## ADDENDUM NO. 1

PROJECT: Saline Area Schools – 2022 Bond Program – MS Rec Complex  
 DESCRIPTION: Addendum No.1  
 BID PACKAGE RELEASE NUMBER: BP #3

1. ADDENDUM No. 1, November 20<sup>th</sup>, 2024 as issued by Kingscott (Attached)
2. Bid Package T4 Draft Drawings, October 22<sup>nd</sup>, 2024 - Saline Middle School Rex Complex as issued by Barton Malow (For Reference Only)

SHEET NO.  
**C6.1**

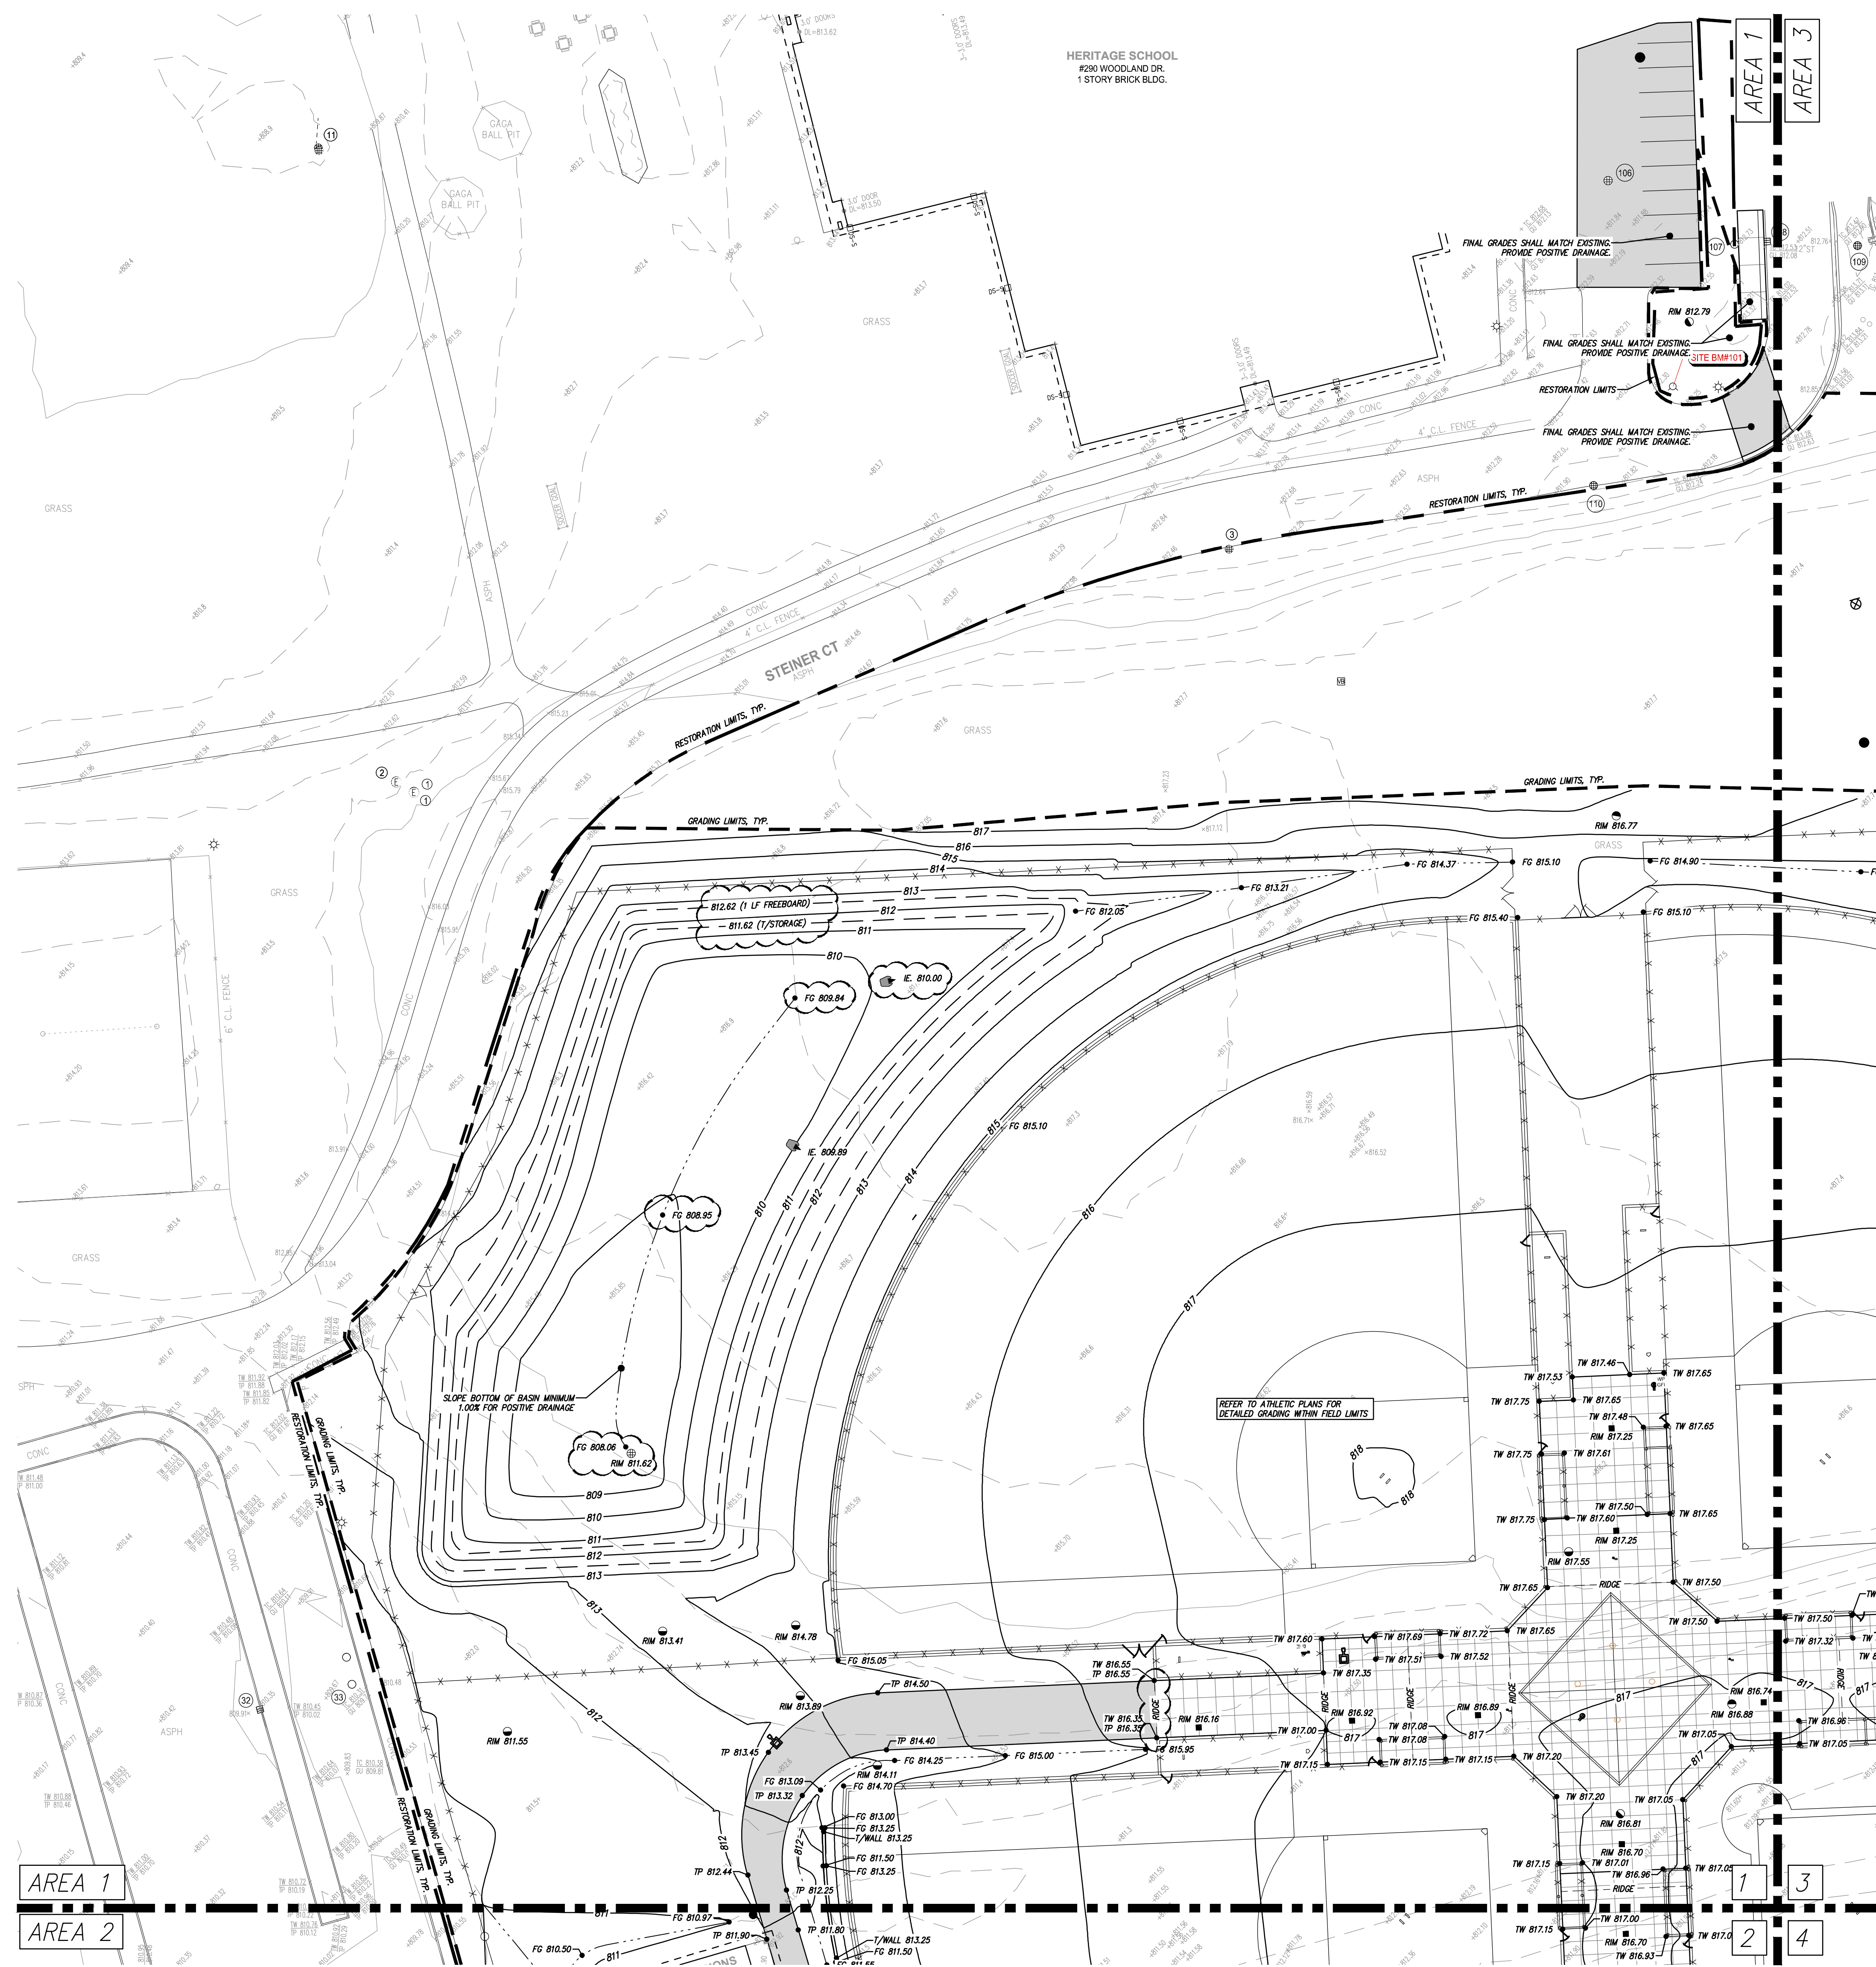
- Item No. 57: Added Hydraulic Pipe Calcs on sheet C3.14.
- Item No. 58: Updated Orifice Calcs on sheet C3.14.
- Item No. 59: Added "Top of Storage" and "Freeboard" elevations on sheet C6.1.

- Item No. 60: Added additional spot grades on sheet C6.1.
- Item No. 61: Updated inverts and rim elevations per utility layout changes on sheet C6.1.
- Item No. 62: Added "Ridge" location and label on sheet C6.1.

SHEET NO.  
**C6.2**

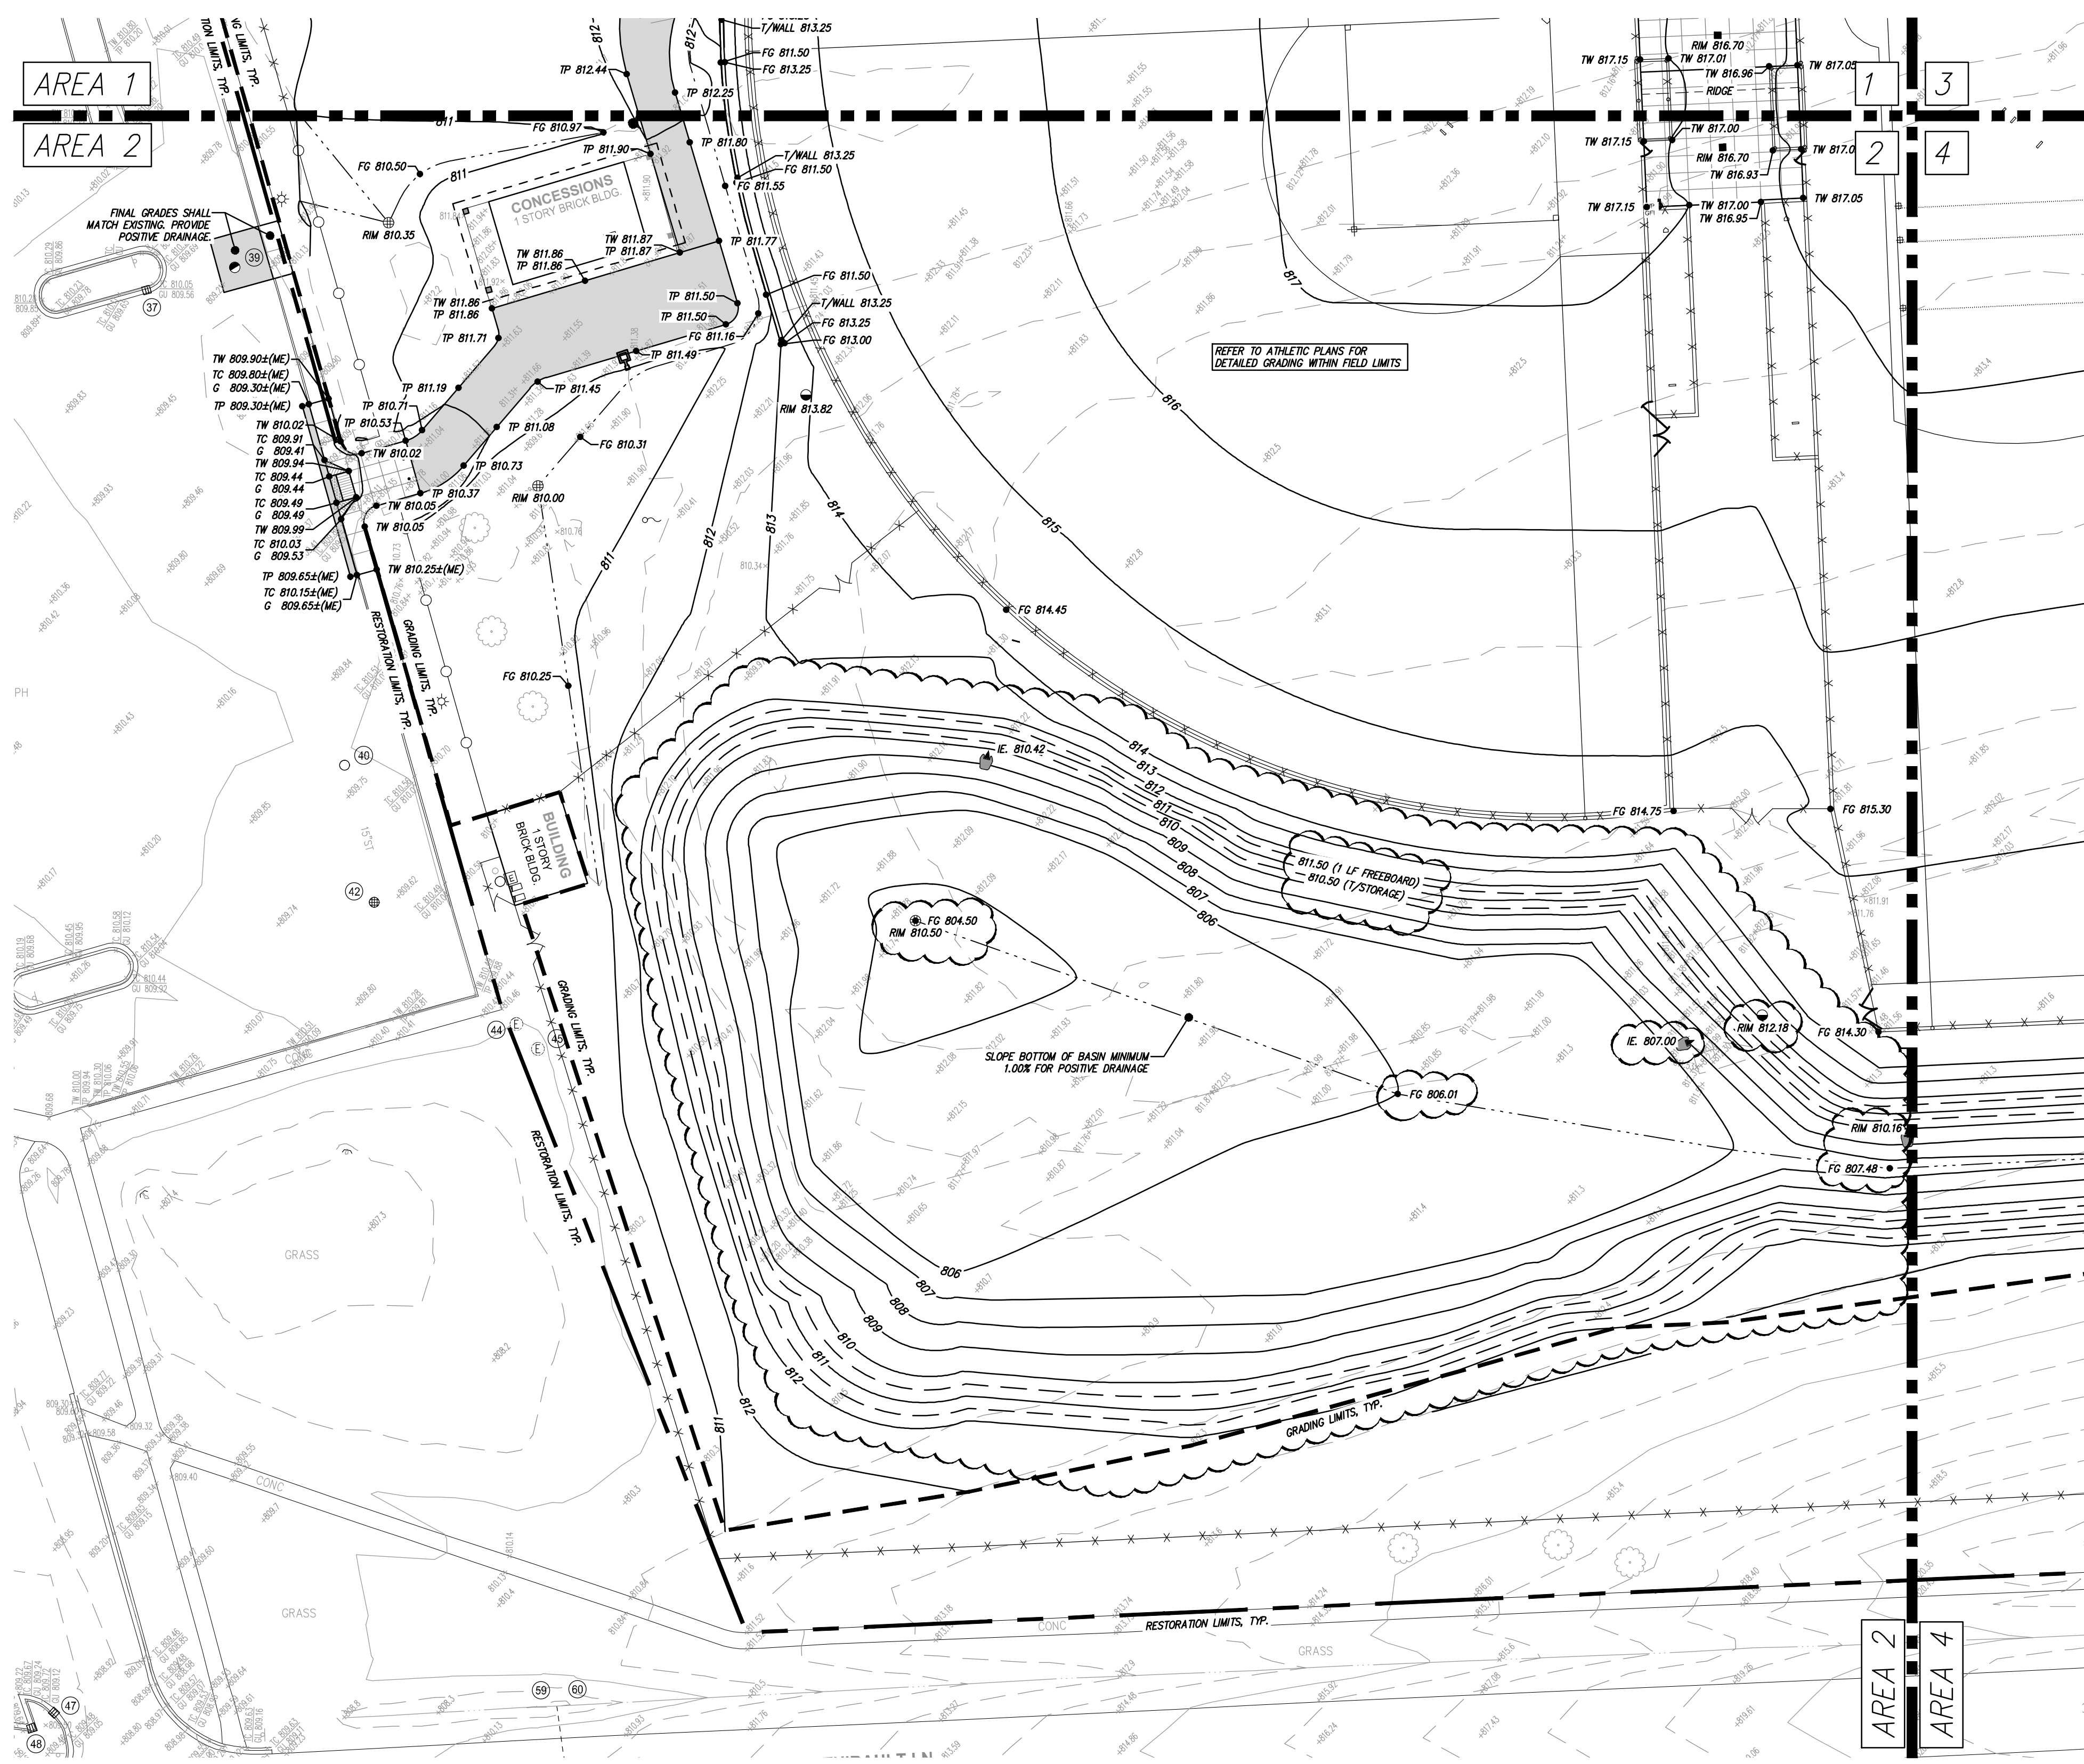
- Item No. 63: Combined "Basin C" and "Basin D" into one basin on sheet C6.2.
- Item No. 64: Added "Top of Storage" and "Freeboard" elevations on sheet C6.2.

- Item No. 65: Added additional spot grades on sheet C6.2.
- Item No. 66: Updated inverts and rim elevations per utility layout changes on sheet C6.2.
- Item No. 67: Revised basin grading on sheet C6.3.
